SAFETY EVALUATION BY THE OFFICE OF NUCLEAR REACTOR REGULATION

SUPPORTING APPROVAL OF CRANE MODIFICATIONS AND USE OF

70 TON SPENT FUEL SHIPPING CASK IF-300

MONTICELLO NUCLEAR GENERATING PLANT

FIGURE 3-1

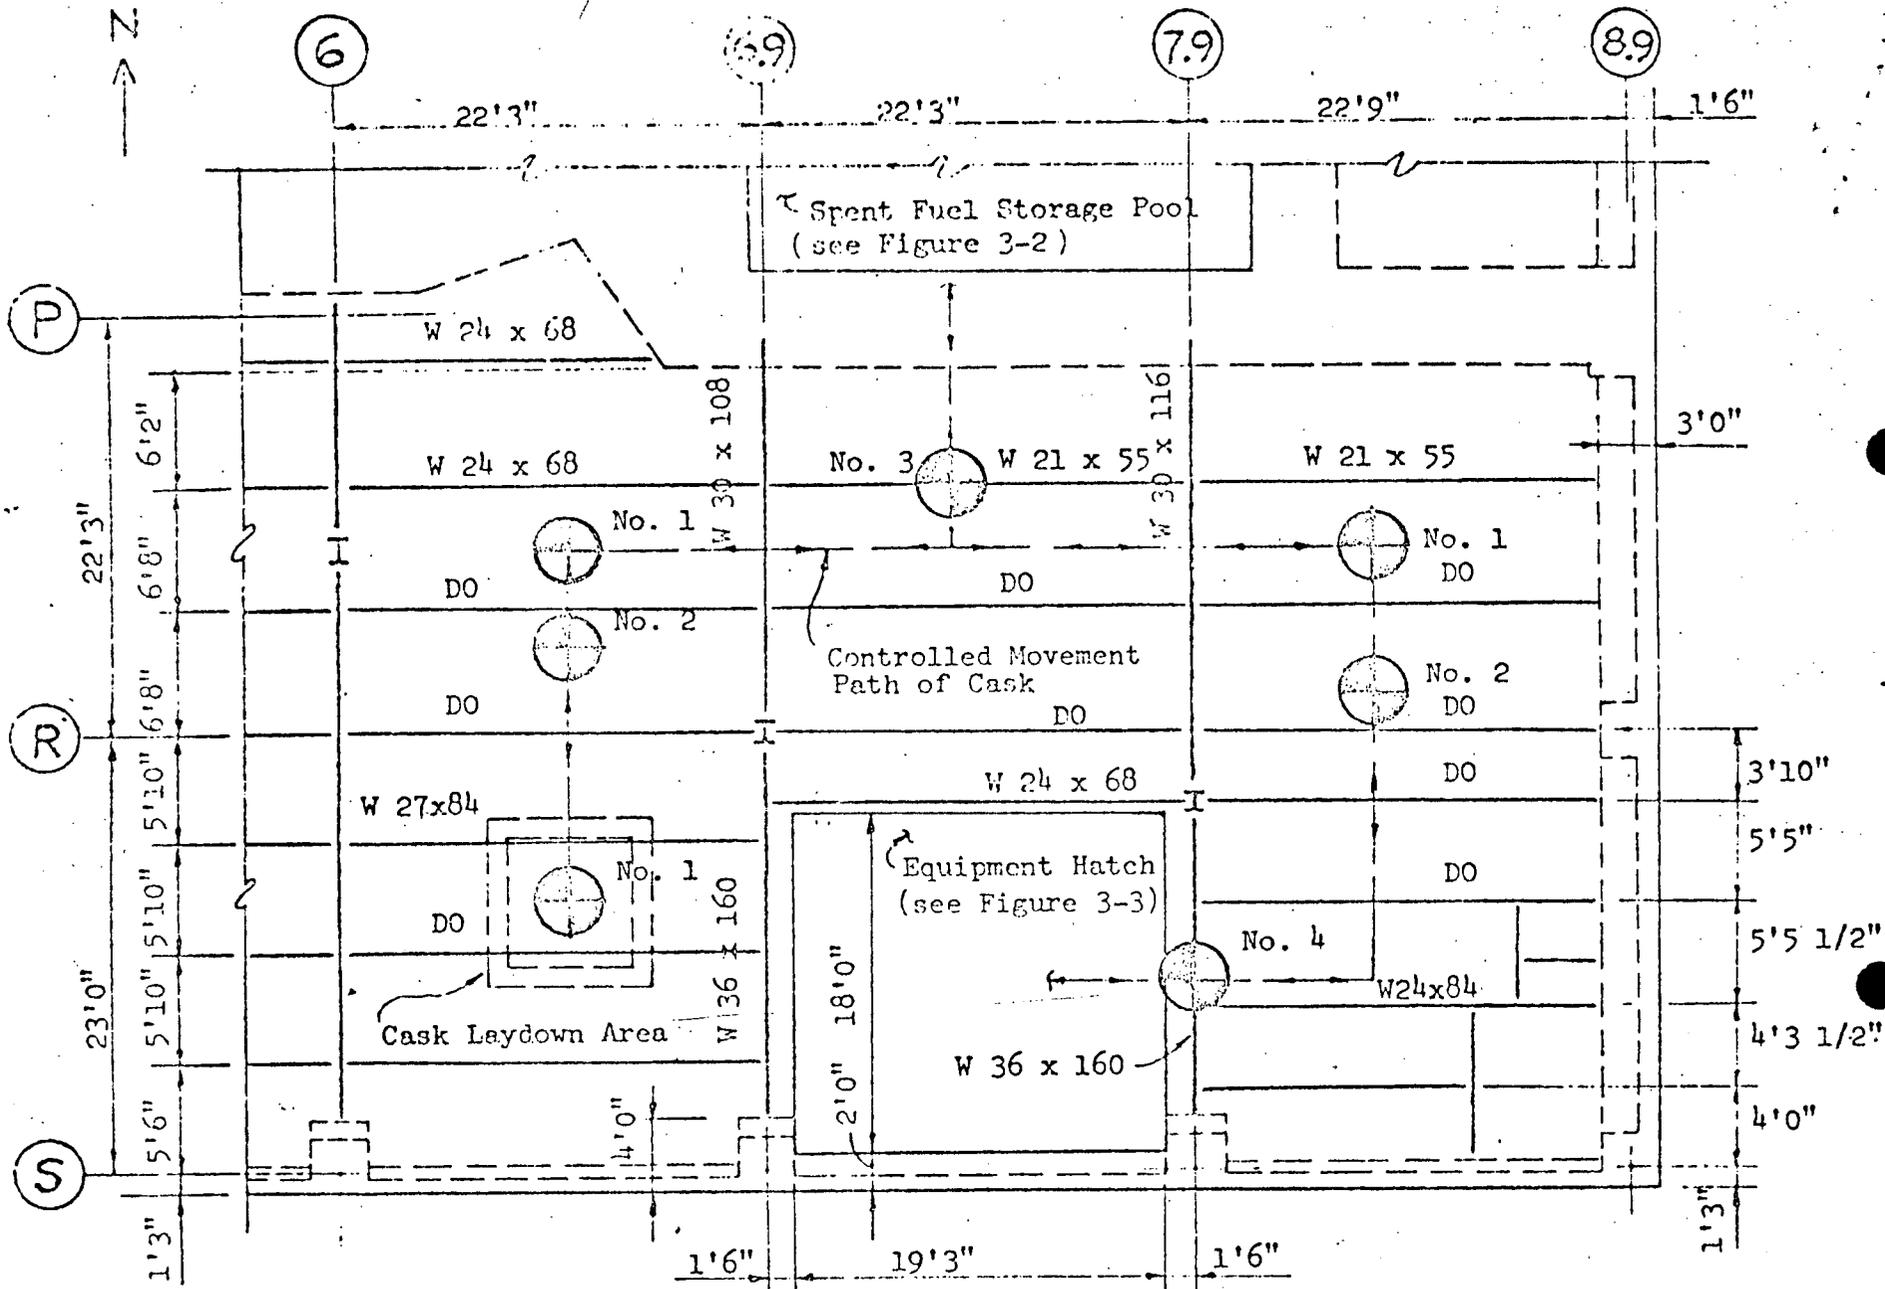
An analysis previously submitted by NSP indicates that the plant's structures are not capable of withstanding the drop of a 70 ton shipping cask. However, the interim program for offsite shipment of spent fuel was limited to the use of a 25-ton cask. The travel path of the cask between the transporter, laydown area, and the spent fuel pool cask loading area was established by the licensee. This travel path passes over those portions of the structure most capable of withstanding a cask drop accident. If the carrying height of the cask above the operating floor does not exceed six inches, the structures are capable of withstanding the drop of a 25-ton cask as indicated by NSP analyses. Figure 3-1 (attached) shows the travel path of the cask in relation to the supporting members below the operating floor.

Postulated cask drop location with bottom end impact

- (1) The carry height of the IF-300 70 ton cask shall be administratively limited to a maximum of the minimum height necessary to gain floor clearance during cask swing, plus two (2) inches; and
- (2) The carry height of the NFS-4 and NAC-1 casks, approved for use in our January 25, 1977 letter, shall be limited to a maximum of six (6) inches; and
- (3) The travel path of all spent fuel shipping casks shall be within the limits established in your January 22, 1976 and June 16, 1976 submittals; and
- (4) Loads of weight greater than 1 fuel element (excluding the crane load blocks and associated tackle) shall not be transported directly over spent fuel stored in the spent fuel pool without prior NRC approval.
